RE: 200 Crandon Boulevard: Variance and Sign Program Applications

RE: 200 Crandon Boulevard: Variance and Sign Program Applications

Re: Key Colony Plaza
200 Crandon Boulevard, Key Biscayne, Florida

KEY COLONY PLAZA

SIGN TYPE: ETL

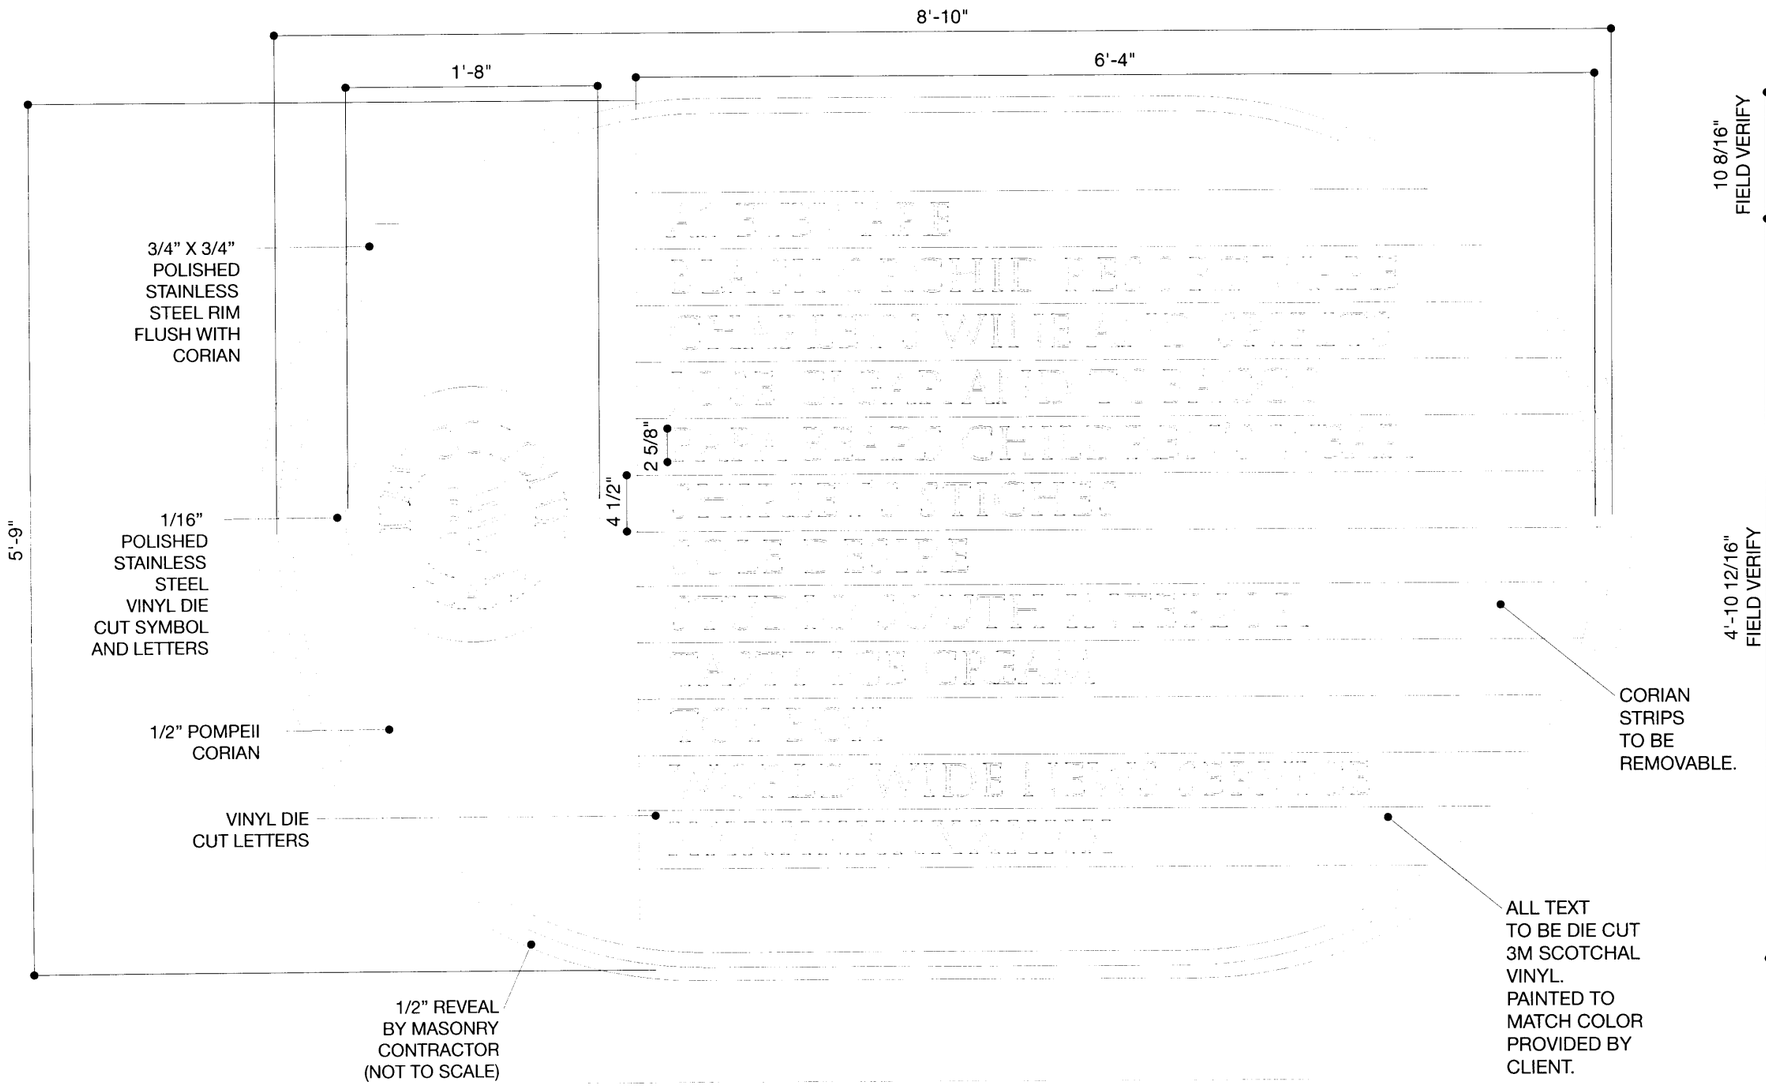
4. The design and color of the directory sign as set forth in the plans are approved however the size shall not exceed the maximum allowed.
5. The round "Key Colony Sign" as set forth in the plans is approved.

4. The design and color of the directory sign as set forth in the plans are approved however the size shall not exceed the maximum allowed.
5. The round "Key Colony Sign" as set forth in the plans is approved.

SIGN TYPE: EXP1, EXP2

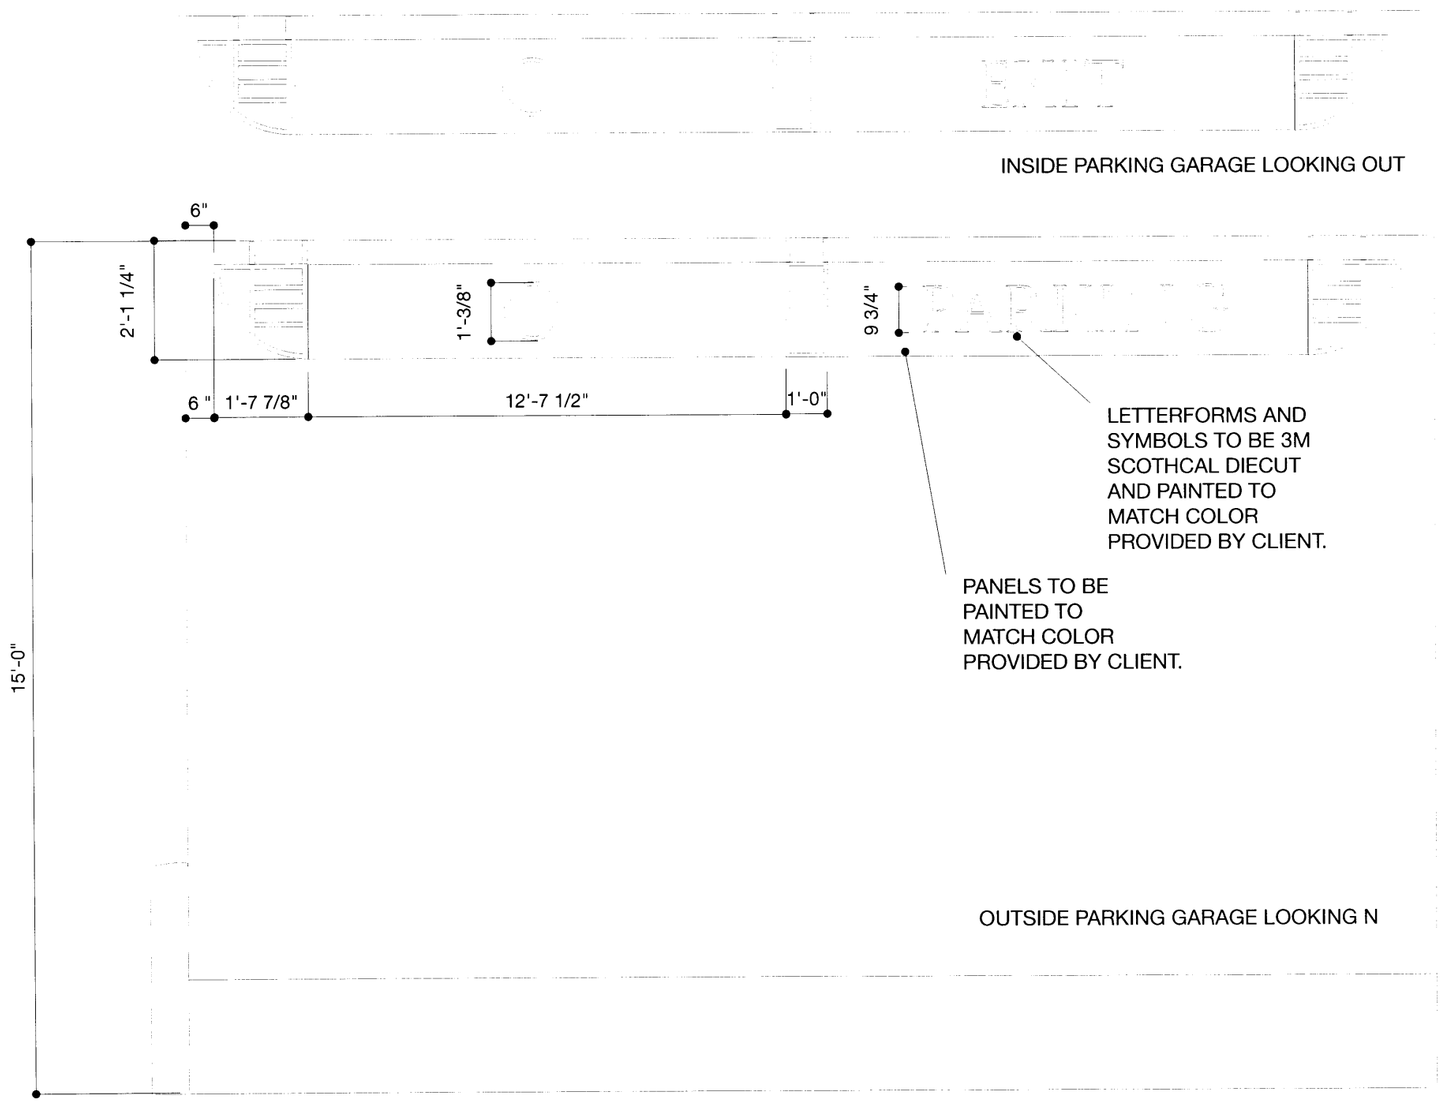
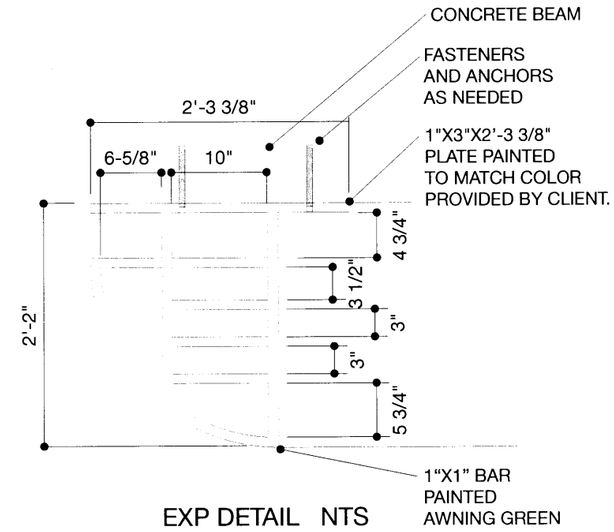
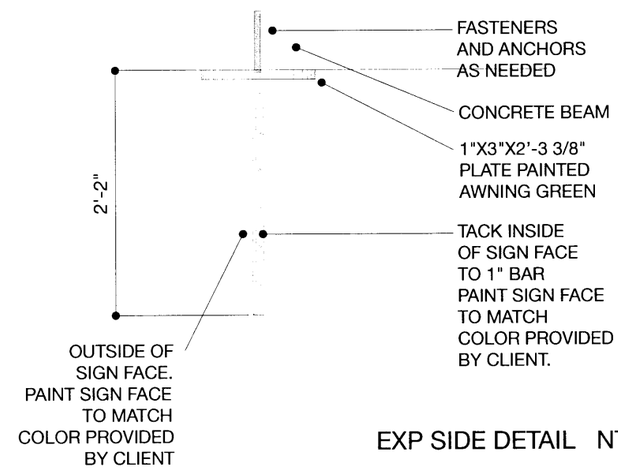
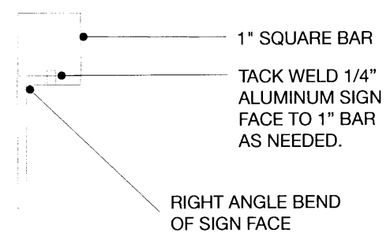
3. Projecting signs can face the interior courtyard with a maximum projection of 4 ft. and letter height of 6 inches. The signs shall have one consistent color and one contrasting color for the letters. The maximum sign area for each sign shall not exceed 5 sq. ft.

3. Projecting signs can face the interior courtyard with a maximum projection of 4 ft. and letter height of 6 inches. The signs shall have one consistent color and one contrasting color for the letters. The maximum sign area for each sign shall not exceed 5 sq. ft.

SIGN TYPE: EM

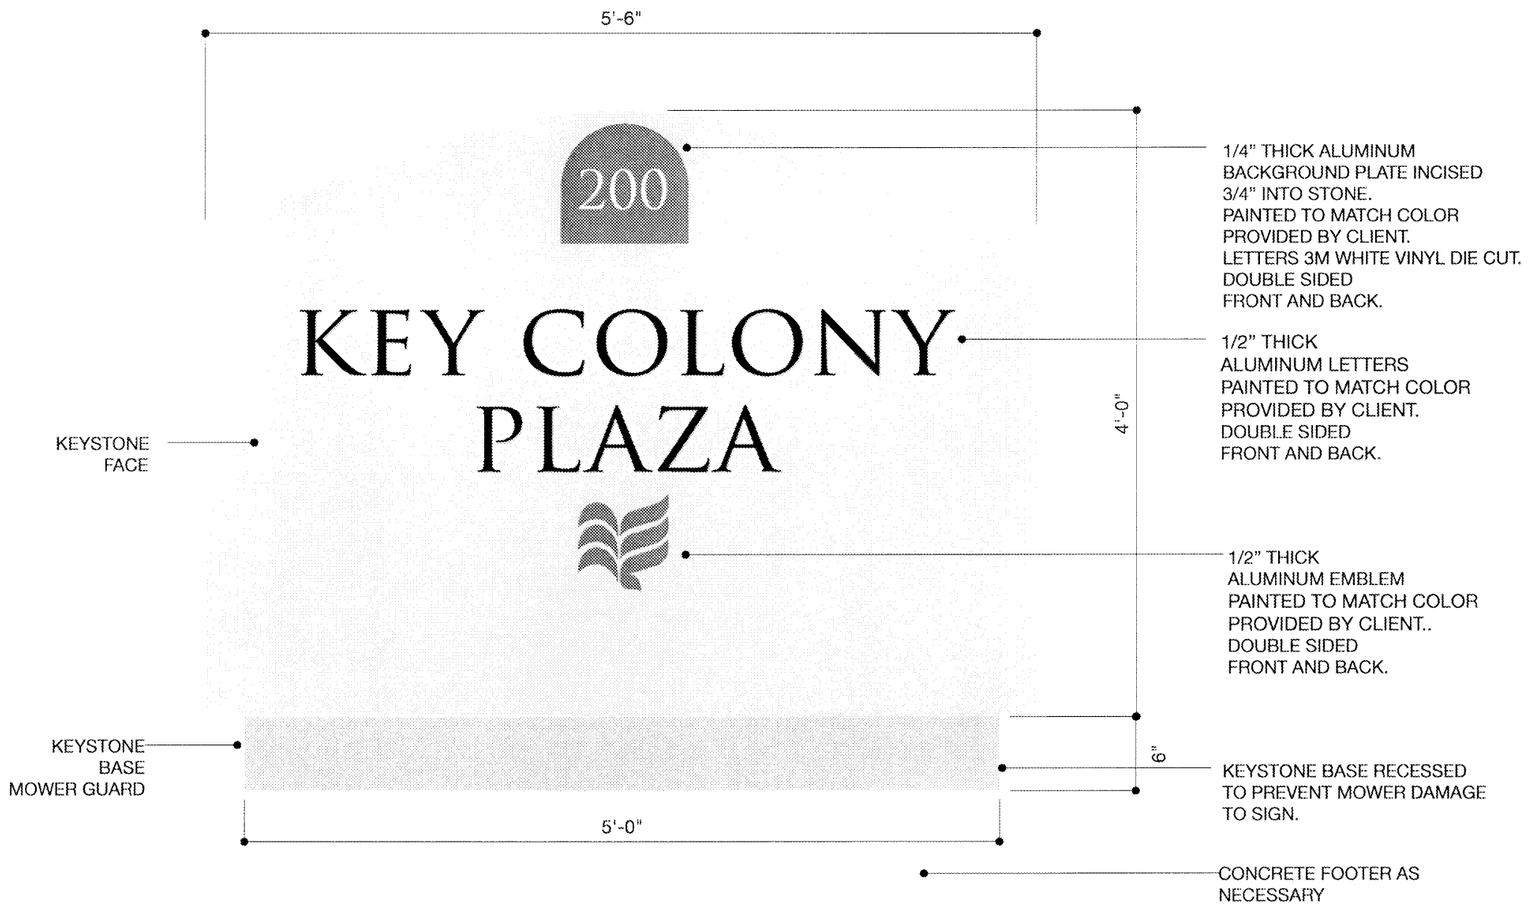
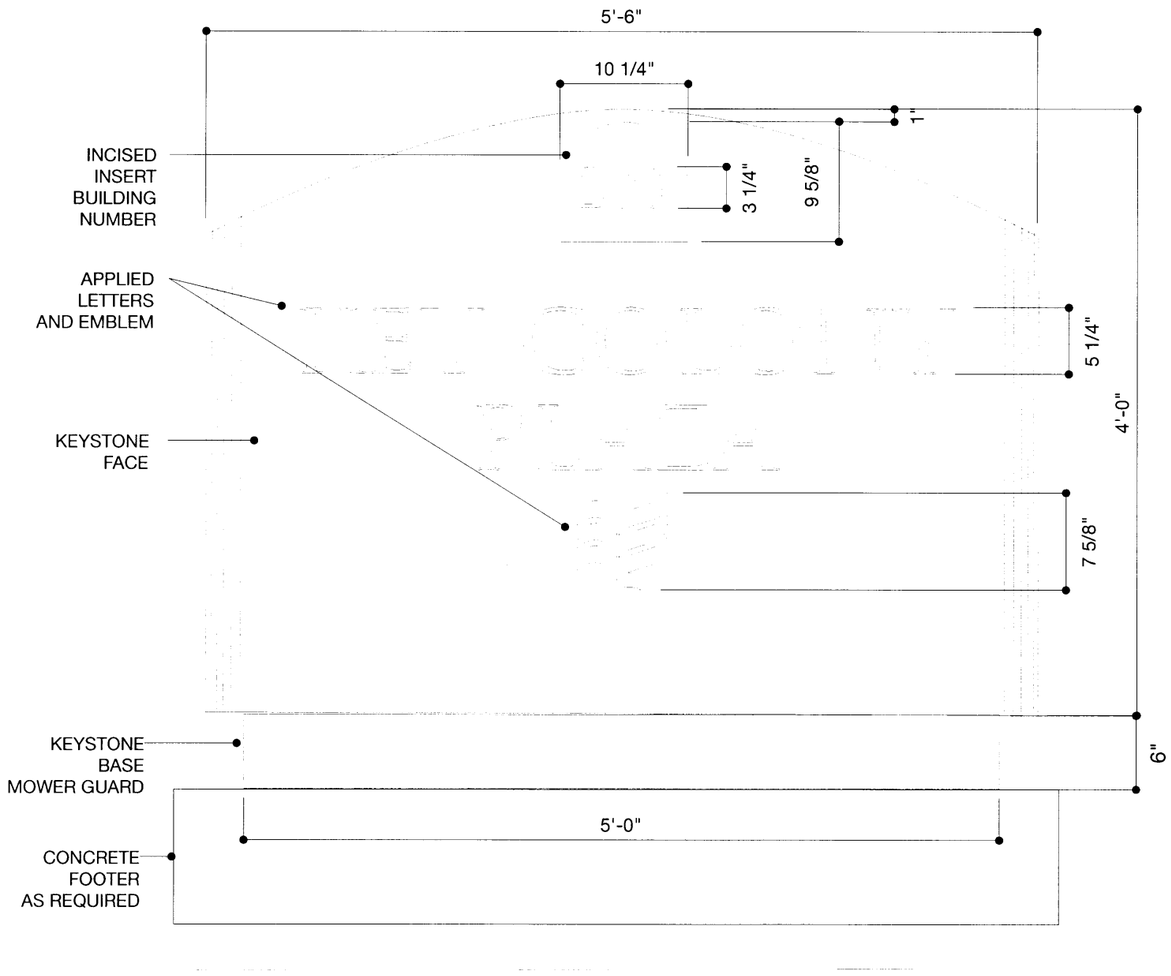
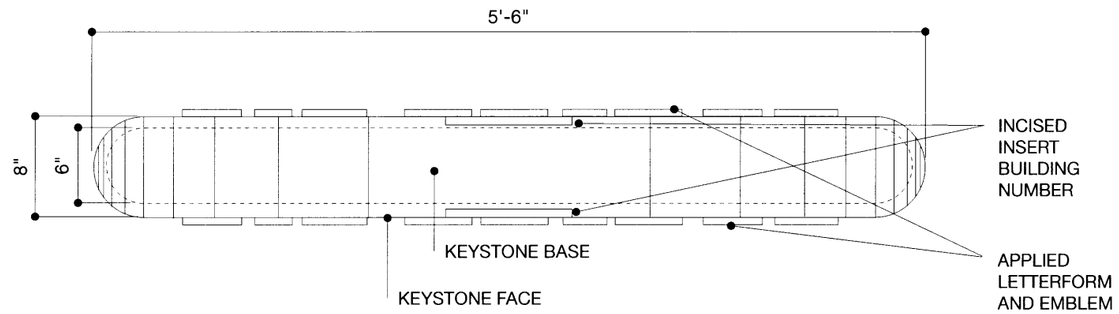
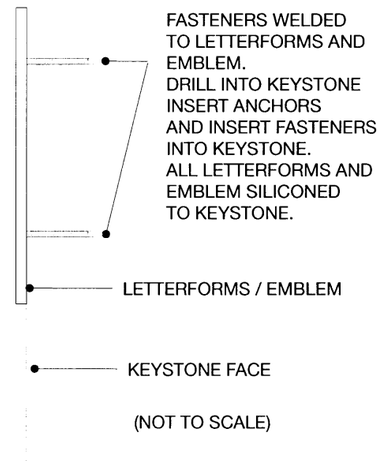
6. A monument sign is prohibited as it would provide signage that is all ready allowed on the building or in the sign directory.
7. Signage facing Fernwood Road shall be non-illuminated and as shown on page 10 of the plans with copy reading "Exit" and "Parking". The sign over the rear entrance shall be as shown on page 9 of the plans and shall not be illuminated. This sign shall use reverse channel letters and have the same color as the signs facing Crandon Boulevard with a letter height not to exceed 8.5 inches as shown on the plans.

6. A monument sign is prohibited as it would provide signage that is all

ready allowed on the building or in the sign directory.
